URBAN DESIGN CONSULTATION RESPONSE

Design Officer	Azhar Kapadi
Date	20.05.26
Application Reference	PL/2026/0196
Address	Land at Egerton Street (Former New Jerusalem Church), Middleton, M24 4QD
Proposal	Erection of seven residential dwellings (Use Class C3) with associated access works including formation of a new dropped kerb, parking, bin storage, landscaping and private amenity space.

Scheme Image(s)

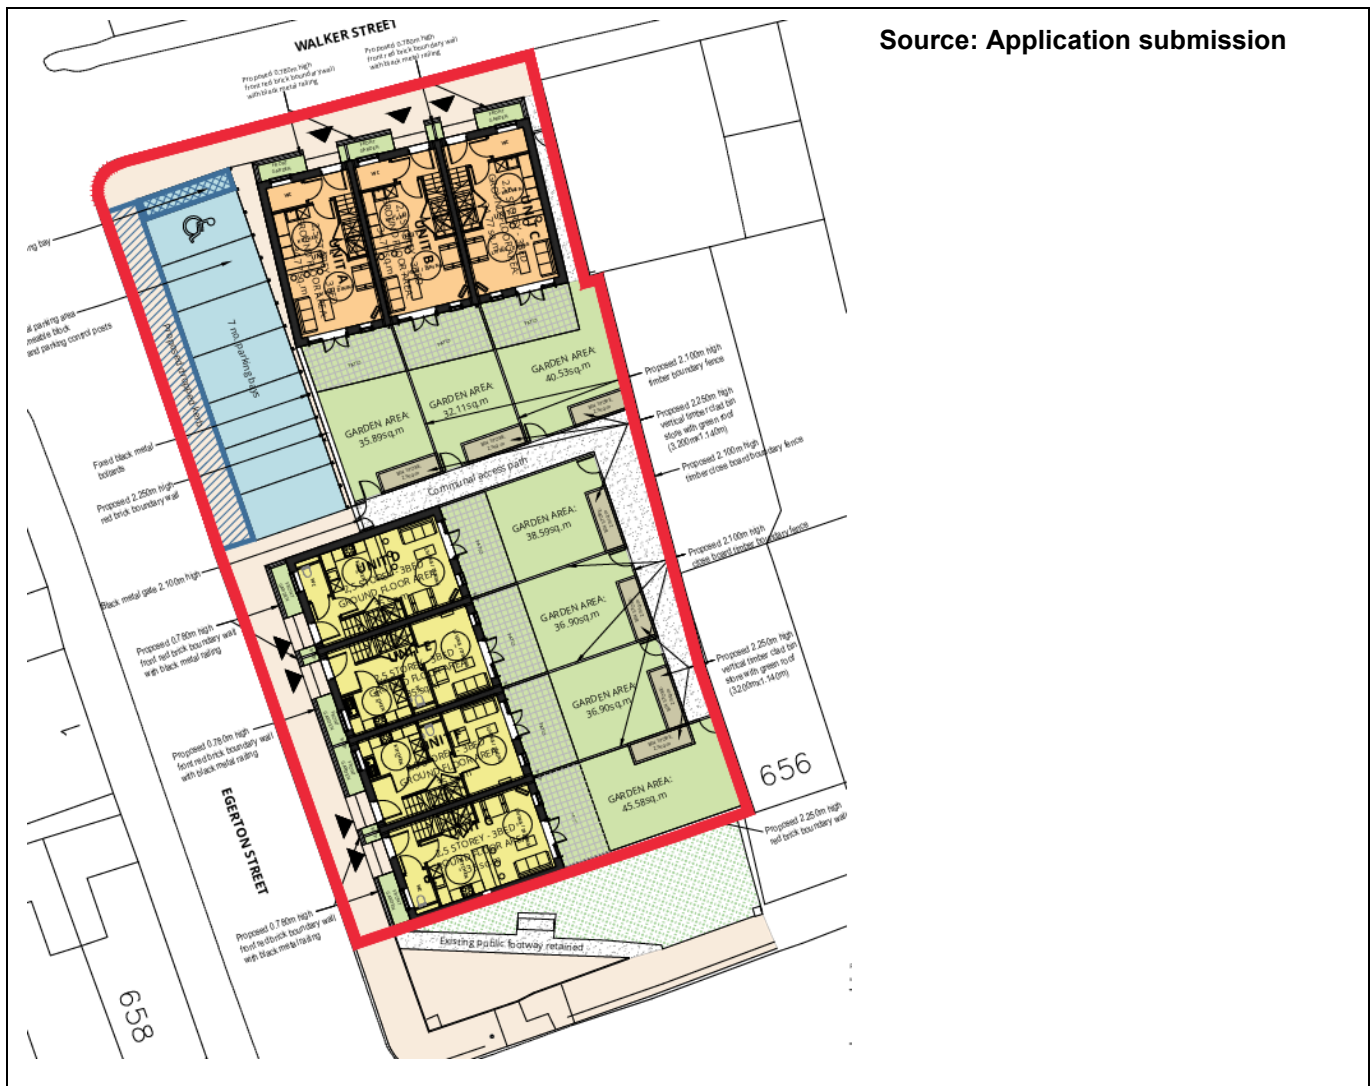
The most immediate design concern is the siting of the car park as currently proposed. It occupies a significant portion of the street frontage and results in an unattractive and inactive corner, which is not supported by design policy.

While the site may initially appear large enough to accommodate seven dwellings, this capacity is significantly constrained once parking provision, access arrangements, and private garden requirements are taken into account. As a result, the current layout appears stretched and leads to compromises in both design quality and the overall street scene.

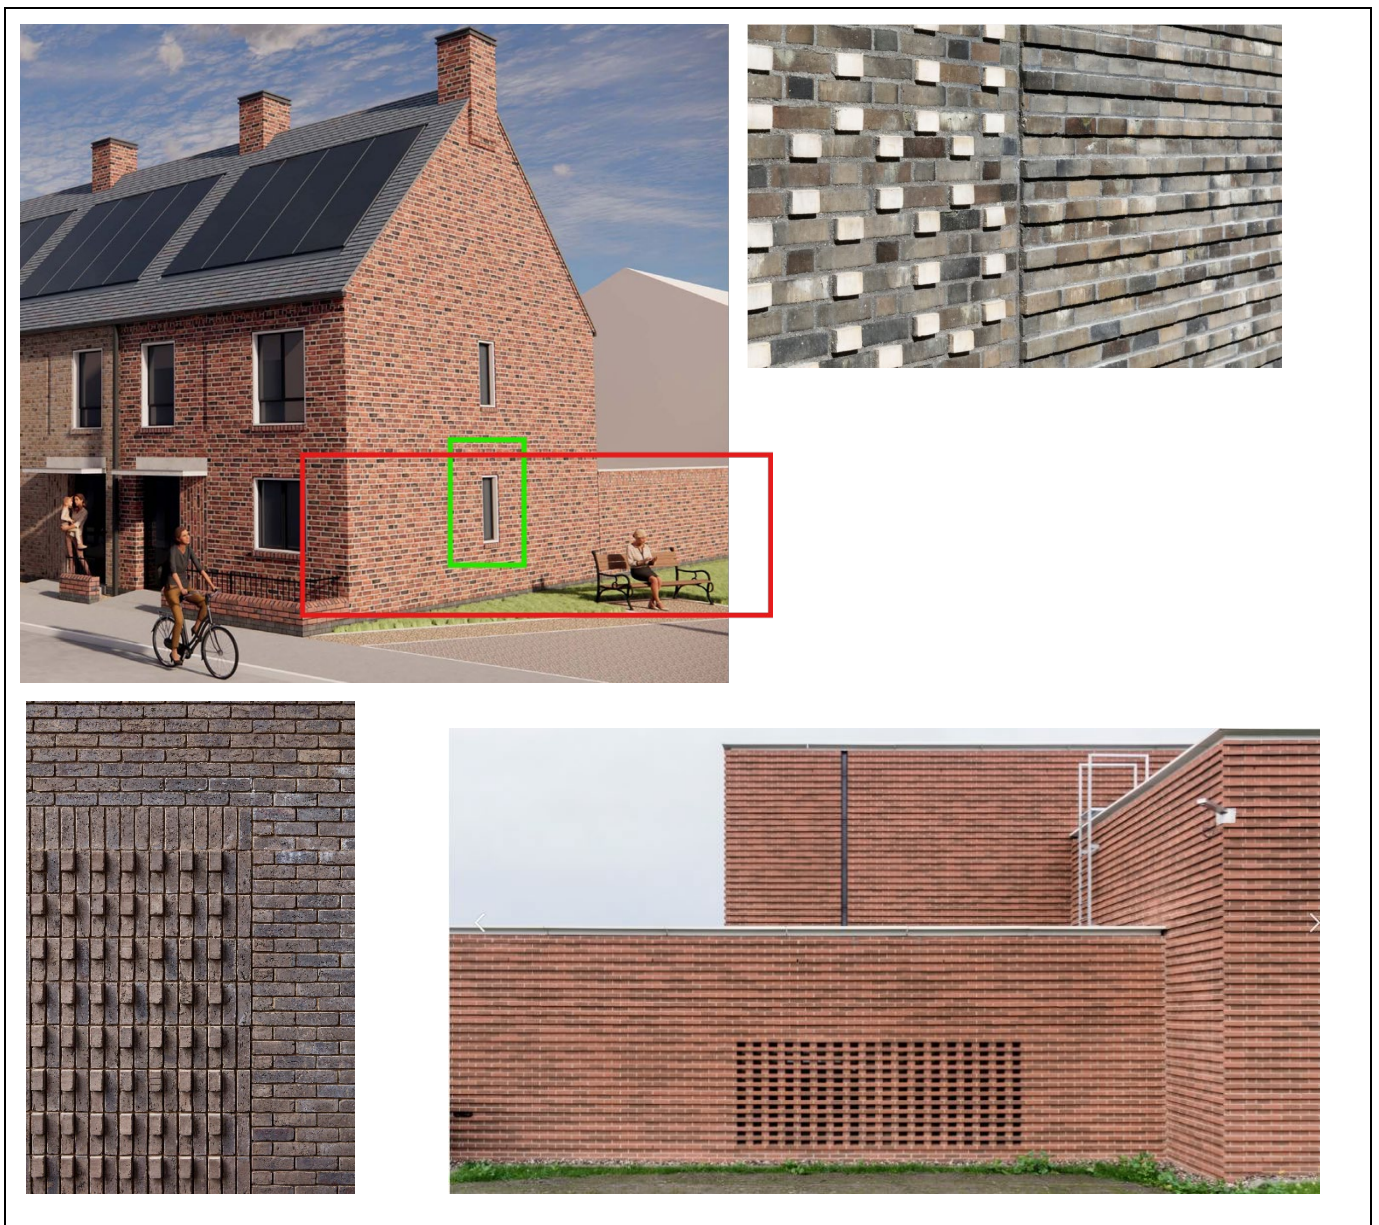
It would have been beneficial to create a stronger frontage along Manchester Old Road, as this would help establish a more coherent and legible street scene. However, this approach would result in long side elevations and extensive boundary treatments along Egerton Street, which is not ideal.

A preferable solution may have been to locate parking to the rear of the site in a courtyard arrangement. This would allow for strong, active frontages to both Walker Street and Manchester Old Road. Achieving this layout would, however, require a reduction in the number of units to enable access to the rear courtyard, and some garden sizes would likely need to be reduced.

In this scenario, high-quality and robust boundary treatments along Egerton Street would need to be carefully considered and justified. While this represents one potential approach to developing the site, it is important to note that relocating parking away from the frontage is likely to result in the loss of one or more units.

Although this may not be ideal for the applicant, it would significantly improve the overall layout and functionality of the site, making it easier to navigate and providing an opportunity to introduce meaningful landscape buffers along the site boundaries.

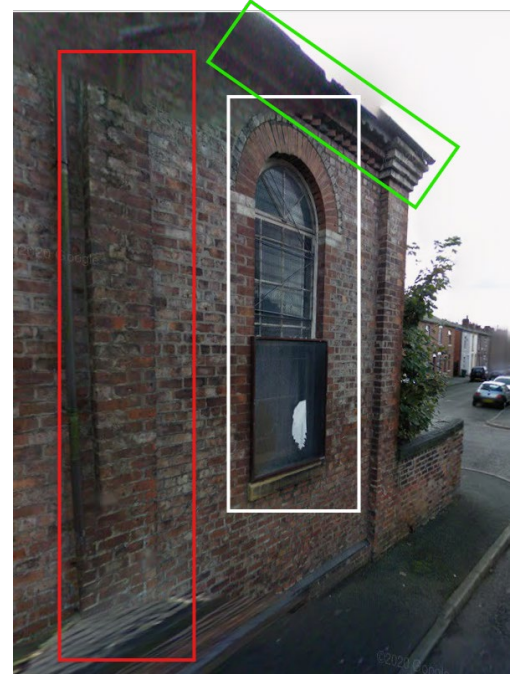
The three-storey options appear overly prominent in height. I would request extending the street elevation to include All Saints Church to better understand the proposal in its wider context. It is important that All Saints Church remains the dominant and most prominent building within the area, and as such, the proposed roof heights should not exceed that of the church.

Front dormer windows are generally discouraged across the borough. Although they are proposed to the rear in this instance, they are likely to remain highly visible due to the site's open and exposed nature, with multiple elevations fronting the public realm.

A more contextually appropriate approach would be to maintain the prevailing two-storey scale of the surrounding terraced housing, ensuring the development aligns more closely with the
